Technical BULLETIN

2007 PZ50W/FXW/GTW/MW/VTW

Quality Assurance Updates – Air Intake Silencer, Engine Mount, and Air Intake Snow Protection

Air Intake Silencer Modification

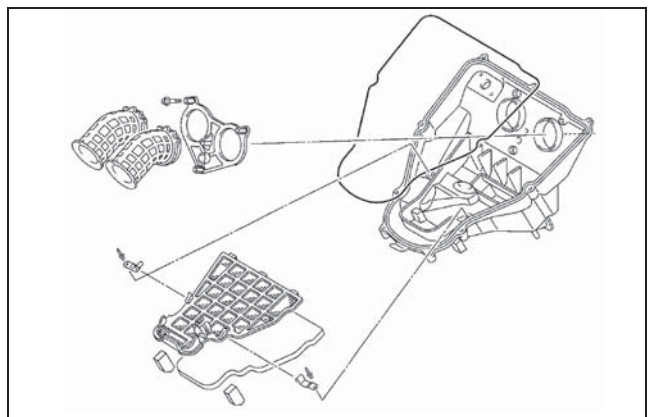
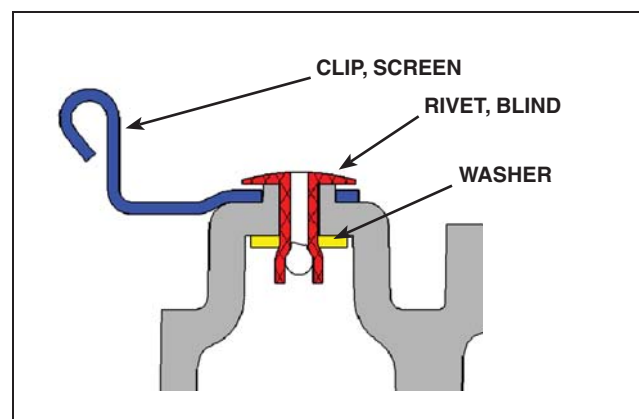
- The Air Intake Silencer Mounting Clips inside the silencer may come loose due to a rivet failure.
- The front left-side engine mount nut may not have reached the specified torque at factory due to a possible uneven contact between the nut and washer.
- During deep-snow riding conditions, the force of the snow may deform the front frame protector, which may allow snow to pass into the air intake system.

- Secure the lower case, and then drill out the original rivet from each clip, using a 3.2mm (1/8") drill bit.

- Reinstall the air silencer mounting clips using the new rivets and washers from the PZ50 Hinge Rivet Kit.

The washer is small and thin; take care to properly locate the washer on the bottom of the intake silencer before installing the rivet so the washer is not lost.

Engine Mount Nut Retightening

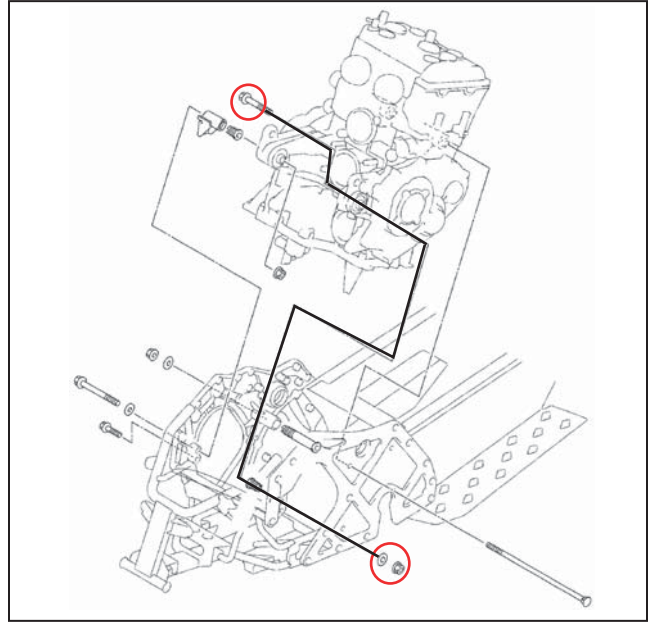
6. Retighten the front left engine mount nut indicated in the adjacent illustration to the new specification below.

Engine mount nut tightening torque:
70 Nm (7.1 kg•m, 52 ft•lb)

Hold the nut with a 14mm wrench and tighten the bolt to specification with a torque wrench and a 14mm socket from the engine side.

Snow Protector Brackets Installation

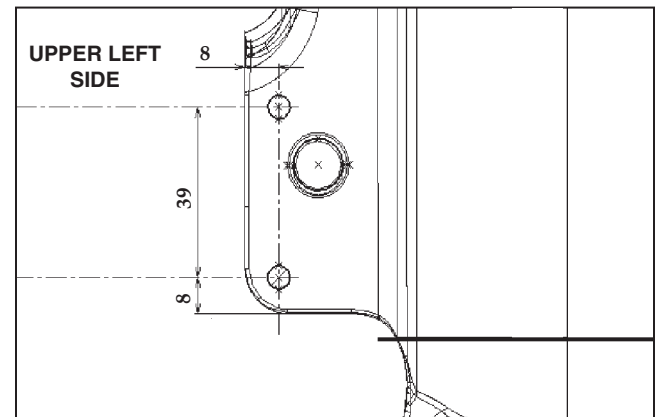
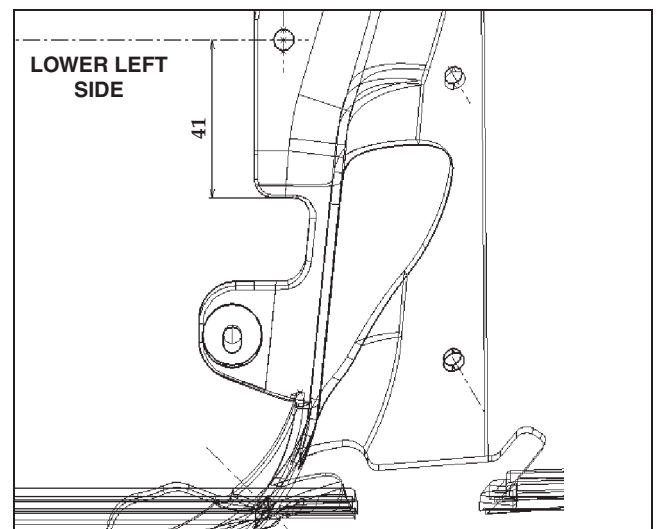
9. For the upper left side marks, scratch a full-length vertical line 8mm from the edge. Mark the location of the bottom hole 8mm from the bottom edge. Mark the location of the top-hole 39mm above the bottom hole. Use one of the small brackets (metal bracket 4) as a template to position the holes in the correct location.

10. For the lower left side marks, scratch a vertical line in the upper region 8mm from the edge. Locate this hole 41mm from the bottom edge.
11. Repeat the procedure from steps 9 and 10 for the right side.
12. Using a 5.5mm (7/32") drill bit, make 6 rivet holes (3 on each side).

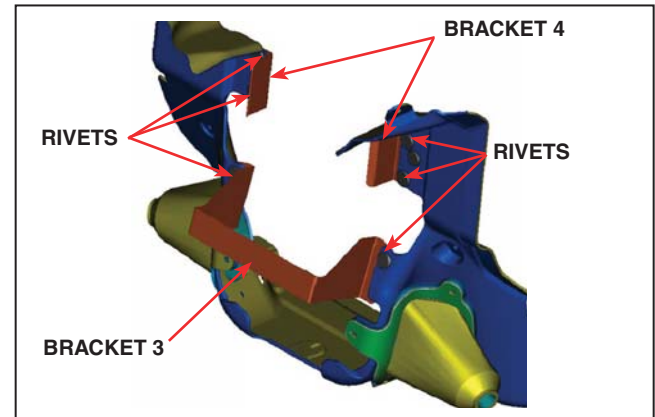
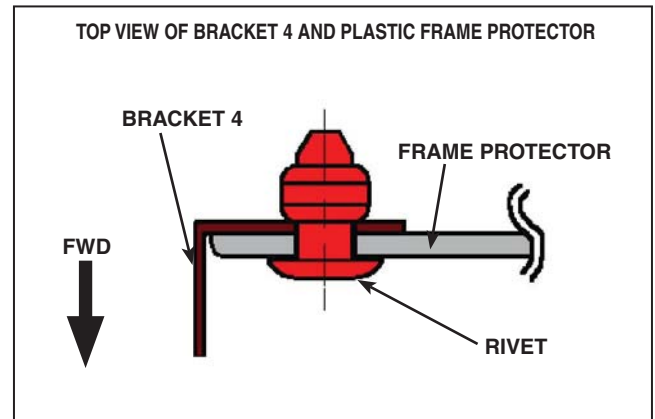
Place all brackets behind the plastic frame protector and rivets in front (see adjacent illustration). All brackets must be orientated towards the front of the vehicle (see adjacent illustration).

14. Insert the rivet through the plastic frame protector in the lower left side and then through the left side of the metal bracket 3 from the PZ50 Snowing Kit.
15. Repeat steps 13 and 14 for the right side.
16. Re-install the front shocks.

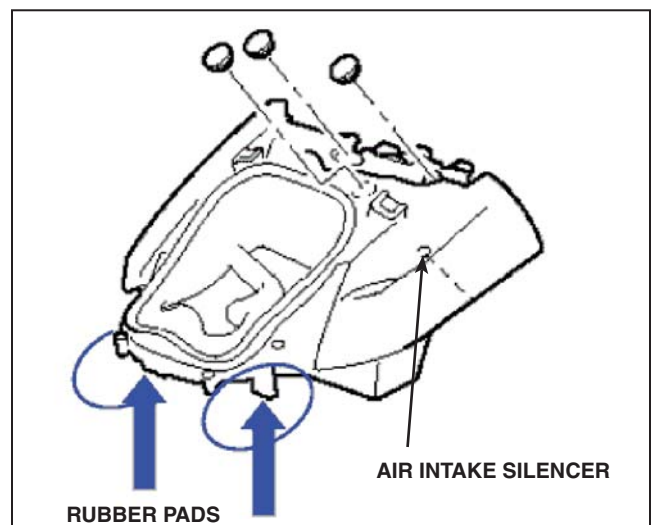
17. For all models except PZ50VT, install the two rubber silencer pads (one right, one left) under the air silencer as illustrated. The rubber pads will press fit around the air silencer contours (see adjacent illustration).
18. Install all parts in reverse order of disassembly.
